Survey of items

91 Driver's seat

91-87111 Driver's seat cushion worn out (vehicles from production period 01/87-08/87).

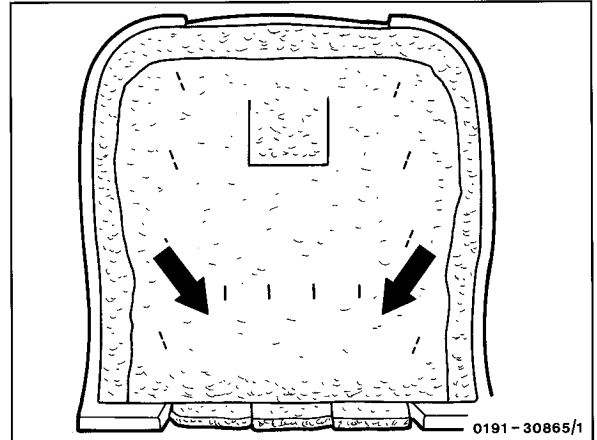
Bottom layer of standard rubber hair support parting from upper layer (Fig., arrows). Supplier's fault.

Replace rubber hair support.

Standard improved as of 09/87

91-88011 Noises from mechanical seat adjusting device when driving around bends.

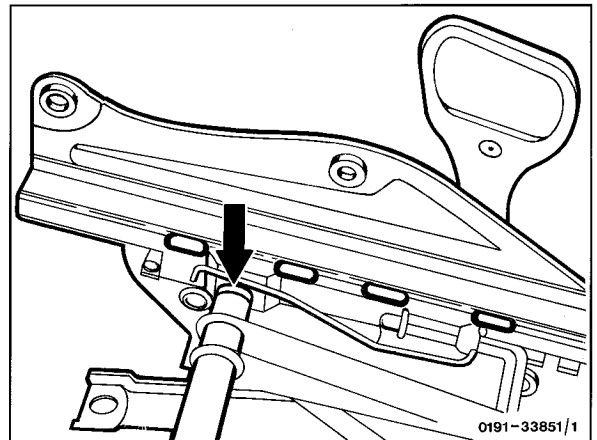
Plastic bushings in transverse tube of longitudinal adjusting lever are causing noises.

Lubricate plastic bushings left and right on removed seat.

91-88021 Noises from seat cushion when driving around bends.

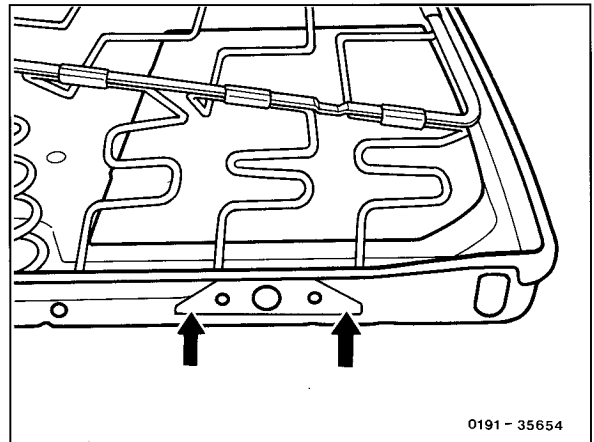
Reinforcing panels of cushion frame are rubbing against seat adjuster.

Straighten projecting ends of the reinforcement plate, lightly file or grind if necessary and grease with door lock grease, part no.

001 989 13 51 10.

- 91-89051
- a) Driver's seat cushion floats or tilts laterally when driving around bends.
 - b) Driver's seat cushion cover damaged on side in the area of tilt adjustment mechanism.

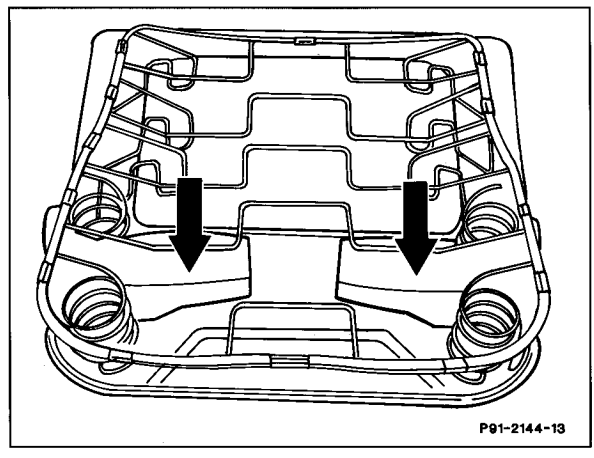
- a) Inadequate lateral guiding of cushion frame.
- b) Cover fabric is jammed in at the inclination adjusting device with heavy load on the seat cushion.

- a) and b) Install foam material wedge (2 off) left and right in the cushion frame.

Part no. 124 910 16 75

Production breakpoint: 04/89 phased-in.

91-89071 Noises on tilt adjustment mechanism

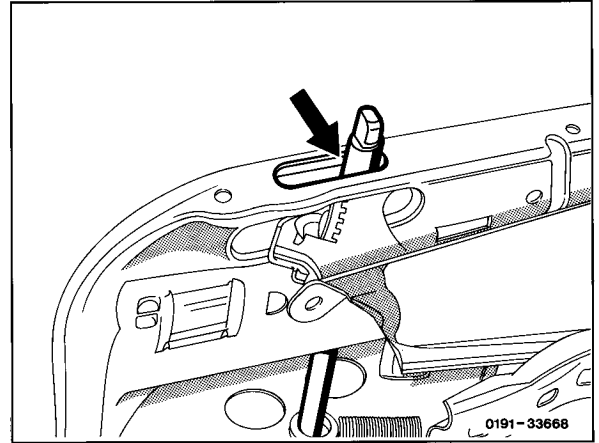
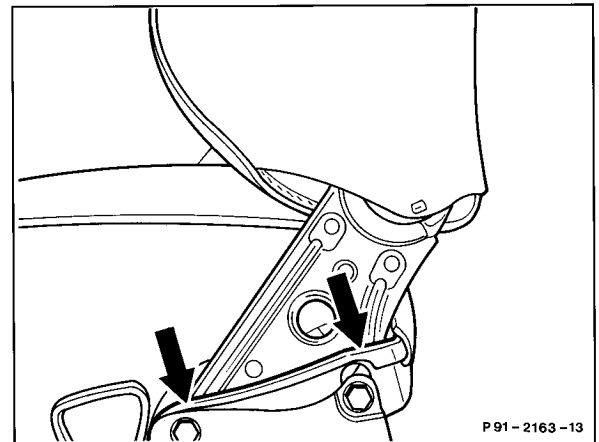
- Tilt adjusting shaft rubs in oblong hole of cushion frame, front.
- Backrest connection rubs against cushion frame or seat adjuster, rear.

- Grease both oblong holes with MB door lock lubricating grease, part no. 001 989 13 51 10. Actuate tilt adjusting shaft several times.

- Lubricate backrest connection (arrows) left and right. For this purpose, force off lining of backrest fitting only. Actuate tilt adjusting shaft several times.

91-89072 Scratching noise in upper backrest range when backrest upholstery is energetically depressed.

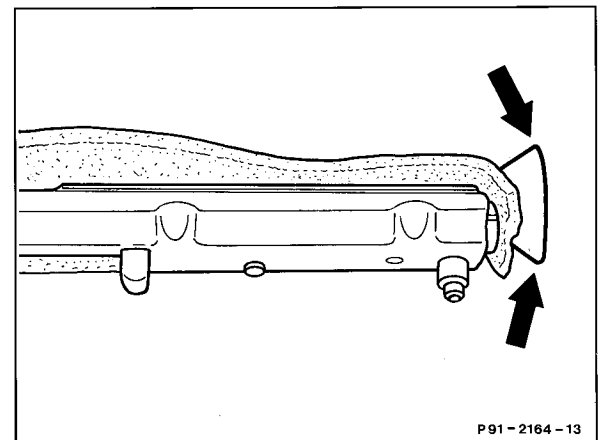
Plastic funnel of headrest guide strip rubs against rubber hair mat.

Remove headrest guide strip. Mask sharp edge of plastic funnel with self-adhesive felt (40 x 2), part no. 001 983 23 10 (arrows).

91-89073 Noises from manual seat height adjusting device.

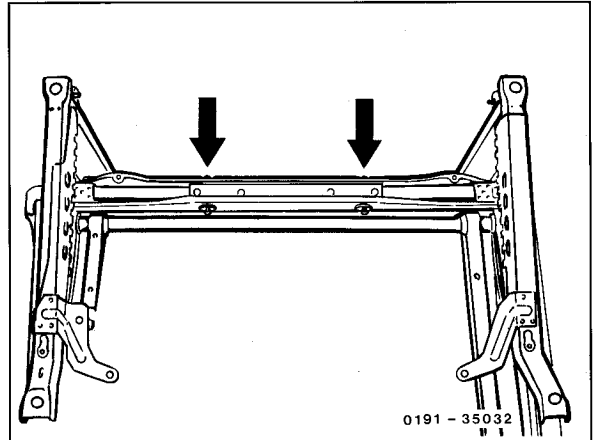
Lever for seat height not lubricated at pivots (2 bolts).

Lubricate bolts on cross member.

Production breakpoint: 11/88.

91-89074 Noise from seat adjuster when driving around bends.

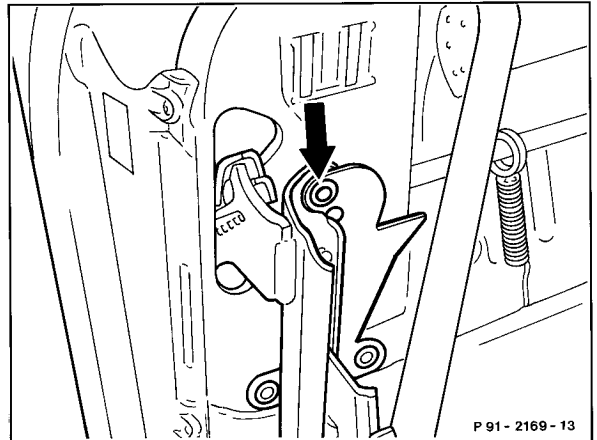
Rivet connection on front leaf spring loose.
Reason: Hole diameter for rivet too large.

Install modified leaf spring, part no. 124 919 03 64/04 64 (with hole diameter 6.5 mm), using rivet 910002 006104. In an emergency, the rivet can also be replaced by a bolt M6 x 10 and nut M6.

Production breakpoint: 04/89.

91-89111 Clattering noises on front passenger airbag unit.

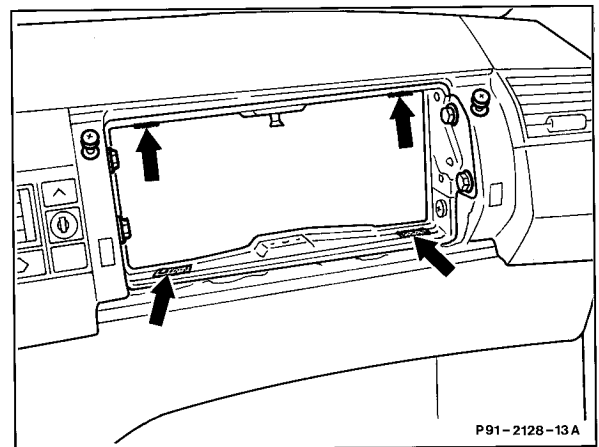
Front passenger airbag unit knocks against installation frame.

Remove front passenger airbag unit (pay attention to safety prescriptions). Cut out 4 felt strips approx. 20 x 25 mm from self-adhesive felt (40 x 2), part no. 001 983 23 10, and glue to inside of installation frame (arrows).
